Final Work Plan

# Removal Site Evaluation Anomaly Area 3

Former Marine Corps Air Station, El Toro, California

August 2002

RSE Work Plan		Final
Proposed Sampling Locations		
Removal Site Evaluation for Anomaly Area 3		
Date: 08-02	MCAS El Toro	Figure 4-3
Project No. 37380	EARTH  TECH A <b>tuco</b> INTERNATIONAL LTD. COMPANY

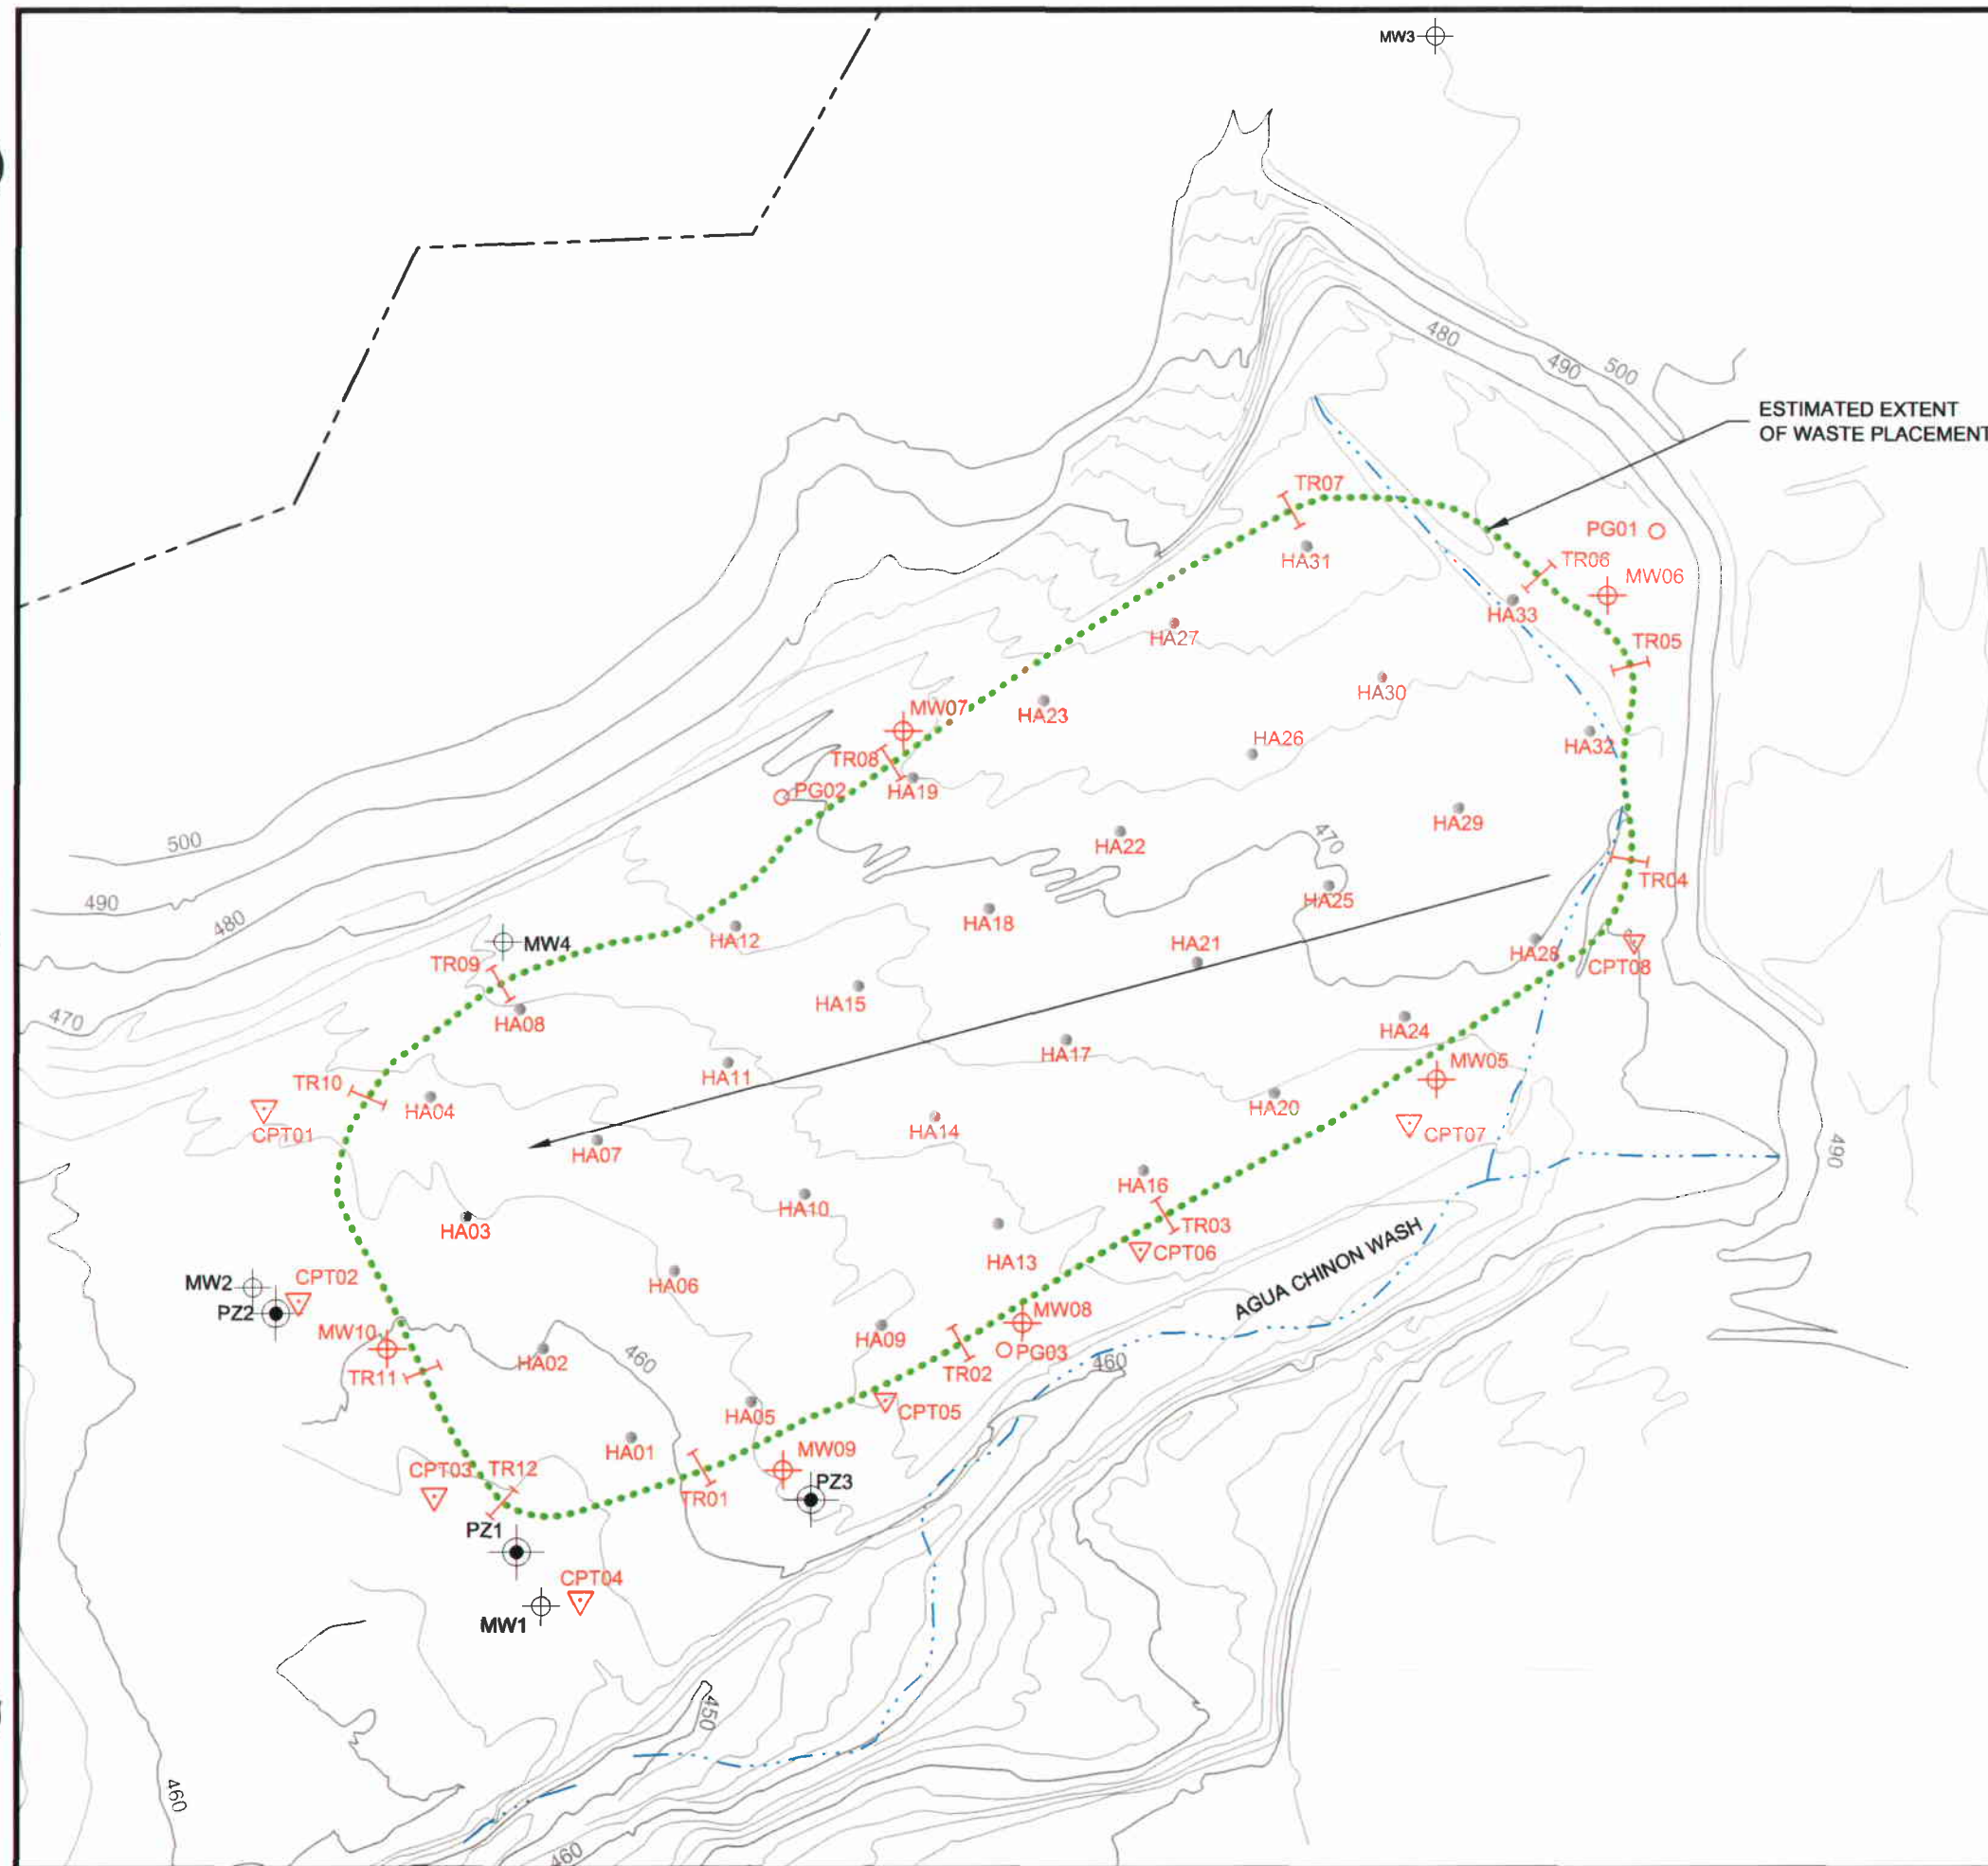
2.	Figure 4-3	Proposed Sampling Locations: Please provide information on which monitoring well will represent upgradient conditions.	Current depiction of groundwater gradient direction was estimated from depths to groundwater measured at existing monitoring wells MW-1 through MW-4.  Based on this, MW-3 is expected to be indicative of upgradient conditions, as will proposed Well MW-6.

3.	Figure 4-3	Proposed Sampling Locations: The Navy should consider adding monitoring wells on the northeast perimeter of the anomaly area as well as on the northern side of the anomaly area.	Please refer to response to general comment #1.

4.	Figure 4-3	Proposed Sampling Locations: Please note on the legend as well as in the text on page 4-16 which samples represent sediment samples.	The exact sampling locations will be determined in the field based on surface water flow if encountered during storm events. Accordingly, the locations are not shown on Figure 4-3. The text indicates that 4 samples will be collected, 2 at upstream and 2 at downstream locations from Agua Chinon Wash. The sampling locations will be surveyed and shown on a figure in the RSE Report.
